# MEMORANDUM

**DATE:** NOVEMBER 28, 2019 **PROJECT:** 116132

**RE:** CLARIDGE / UNIFORM DEVELOPMENT (CU DEVELOPMENTS)  
SANITARY AND WATERMAIN SERVICING OPTIONS

**PROPOSED ALTERNATIVE WATERMAIN SERVICING FOR FUTURE / EXISTING LANDS**

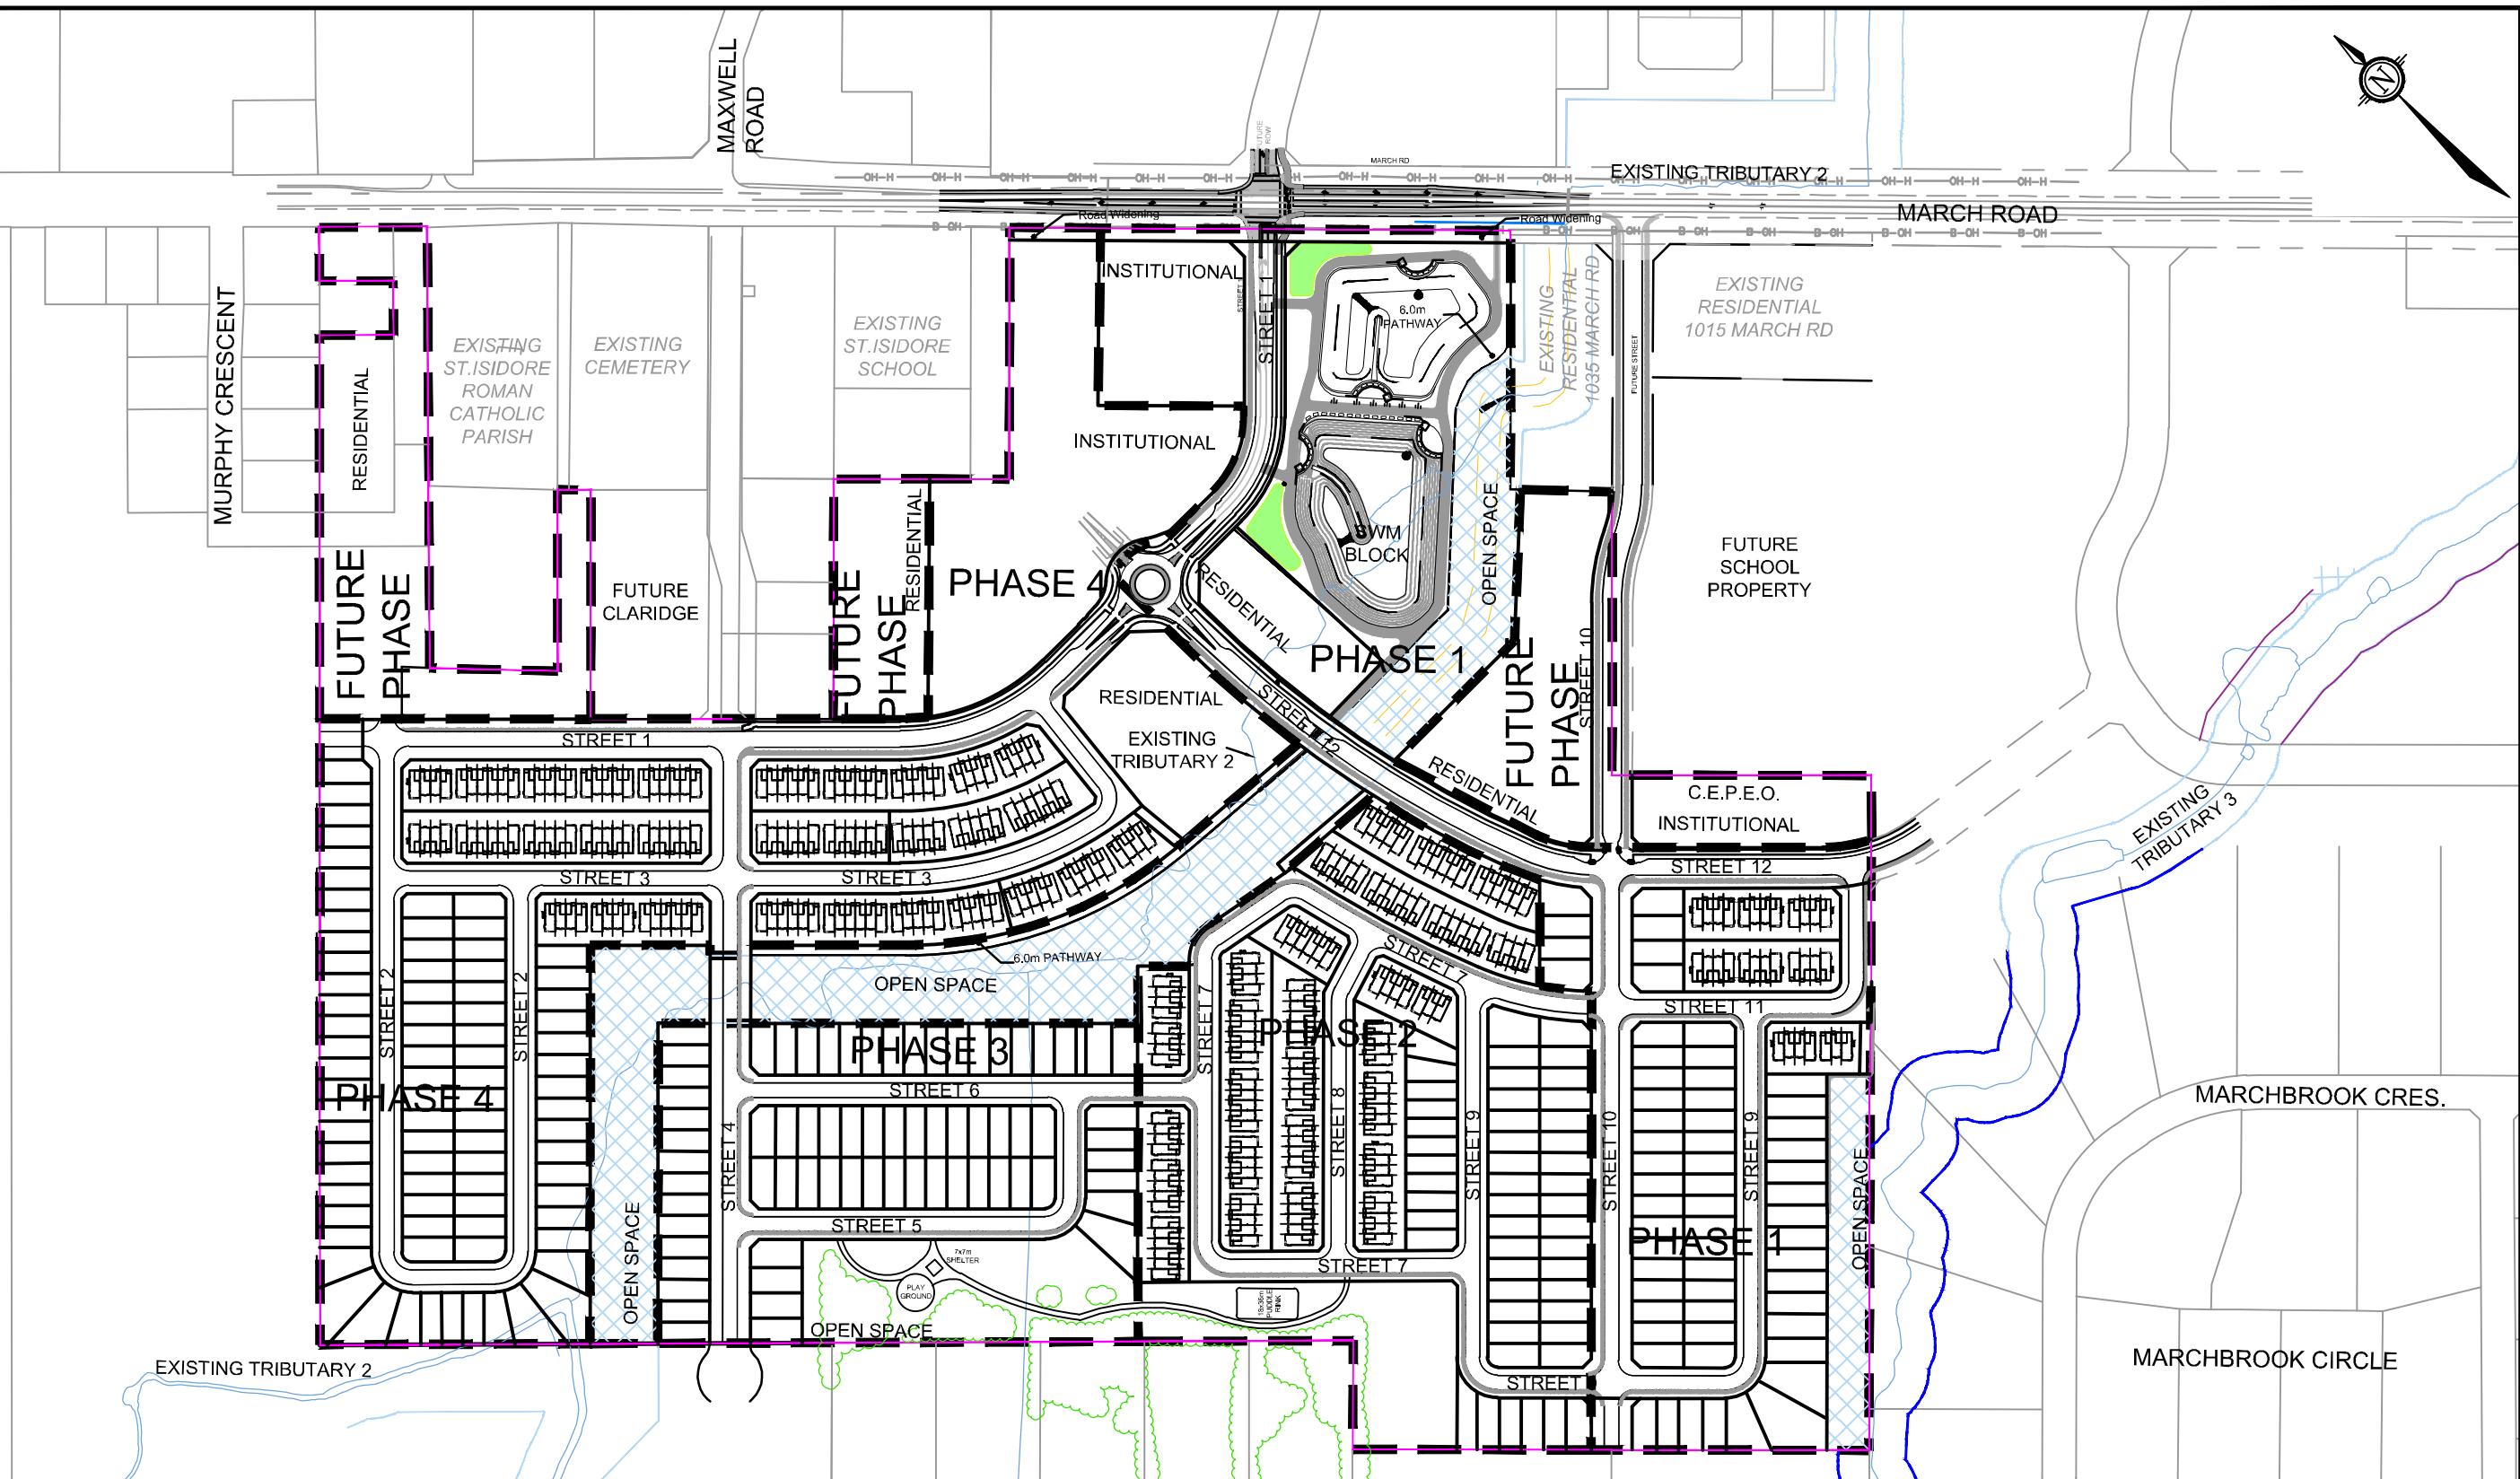
As mentioned, the future / existing lands will be subject to land exchanges and a road pattern is to be confirmed during future development applications. In a case where a loop system cannot be established between Block 300 and Block 298 / Existing St. Isidore School lands, an alternative servicing layout has been provided. The alternative servicing option will provide two separate dead-end watermains capable of servicing all areas of the future / existing lands, with each watermain connecting to the 300mm backbone watermain on Street 1. The first connection will be to the Street 1 / Street 2 intersection and the second connection will be at the Street 1 / Street 4 intersection. Refer to Figure-WM1B – Proposed Alternative Watermain Servicing for Future / Existing Lands for details.

Both single feed systems are approximately 300m in length and therefore headlosses are greater within these pipes under the fireflow condition. A 250mm is necessary through the existing and future lands to maintain reasonable allowable fireflows adjacent to March Road. Fireflows with a single feed system are reduced compared to the preferred servicing strategy which has a loop system through the St. Isidore lands. This option provides:

- 1) A maximum fireflow of 135L/s is achievable adjacent to March Road and Murphy's Court. Detailed fireflow calculations using actual unit type and layouts and hydraulic modelling will be necessary in this location to determine if the adequate fire protection can be provided in this location.
- 2) A maximum fireflow of 148L/s is achievable adjacent to the existing St. Isidore School and 164L/s adjacent to the future Claridge lands containing medium density residential blocks. Greater fireflows adjacent to institutional and medium residential blocks provides greater flexibility with unit types, construction material and layout in these areas. Detailed fireflow calculations using actual unit type and layouts and hydraulic modelling will be necessary in this location to determine if the adequate fire protection can be provided in these locations.
